ARCO Redevelopment Project – 2375 Quimby Road

File No. CP17-028

Initial Study/Mitigated Negative Declaration

RESPONSES TO PUBLIC COMMENTS AND TEXT CHANGES

Exhibit C: Truck Turning Exhibit

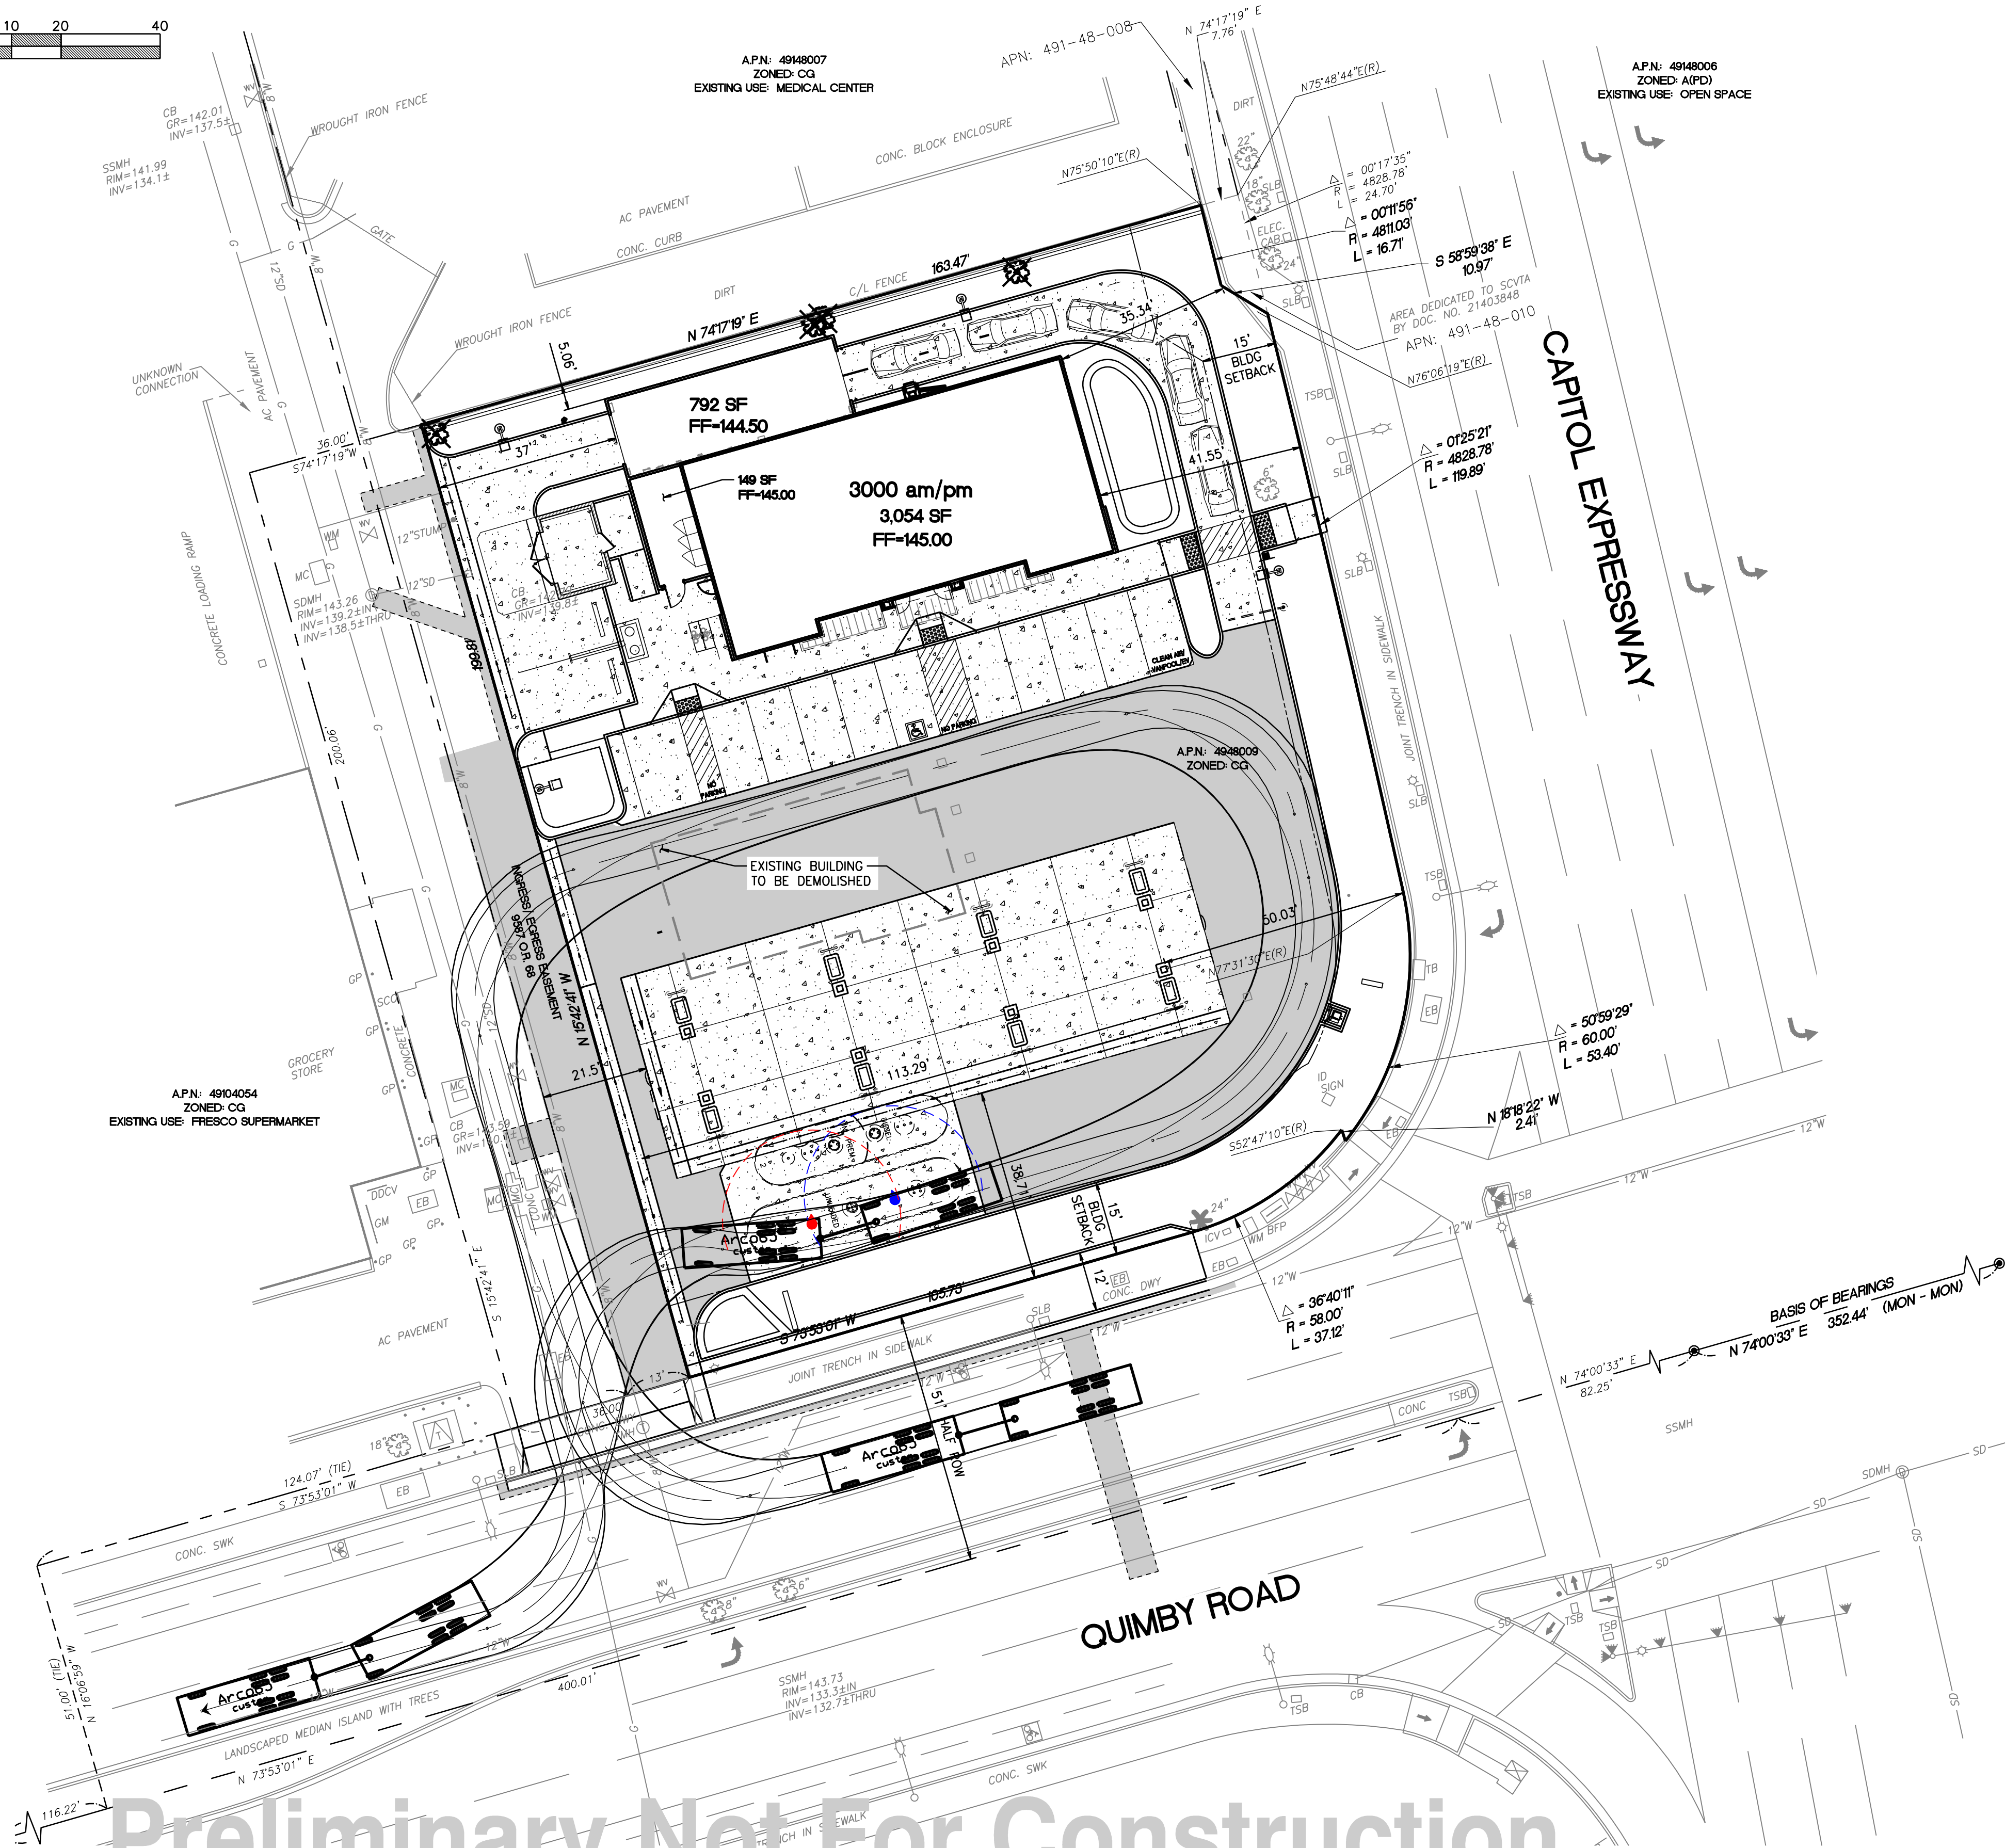
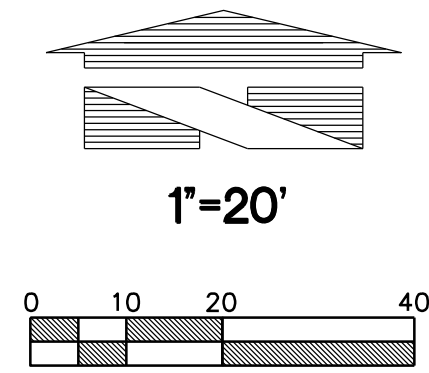
Comment A2: For traffic, as a person who was born and raised down the street from this site I am surprised that this operation is allowed to expand given the operational deficiencies it has now. No plans to change the ingress/egress are part of this project. Where are the traffic counts? Was there any taken? Why not? How about the signal light? Cars already spill into the intersection trying to make this dangerous curve with competing vehicles turning in from Capitol at the gas station entrance? Does this driveway meet city standards for viewing distance between a turn and a driveway? How, what is the standard? Queing - how will this project improve queing or reduce it? What is the LOS? Will this make the intersection worse? How or how not? This intersection gets backed up bad and traffic spills back into the incoming lanes. Chaos at best at times, none of these conditions came through in the analysis. The CEQA checklist was not fully addressed and the items for Traffic were not completely analyzed. This is an unsafe intersection and will result in dangerous turns and maneuvers. At best when delivery trucks (not discussed in their frequency here) come to the site they will block incoming vehicles even more. The description in the Traffic section only states the route of a garbage truck without any specificity as to their exact definitive maneuver or route. In order to assess impacts these routes and turning tables, and queing impacts should be known now.

Comment B3: Please submit a proposed traffic circulation plan and truck turning radius to accommodate the additional gas pumps, convenience store, carwash, and other proposed improvements on site.

Fuel trucks were analyzed by the design engineering firm; the truck template is shown in a screened condition in the overlay attached to this document, demonstrating that fuel trucks can access and make turning movements given the site configuration. Garbage trucks, which have a smaller turning radius than fuel trucks, will be able to enter the site via the west driveway and will be able to access the trash enclosure. Delivery trucks are also smaller than dual tanker fuel trucks and can transit the site without causing undue delays at the driveway. Turning and circulation movements will therefore be possible given the smaller sizes of these respective vehicles.

Response B3: This plan has now been supplied to the City of San José and is attached to this document (See Exhibit C).
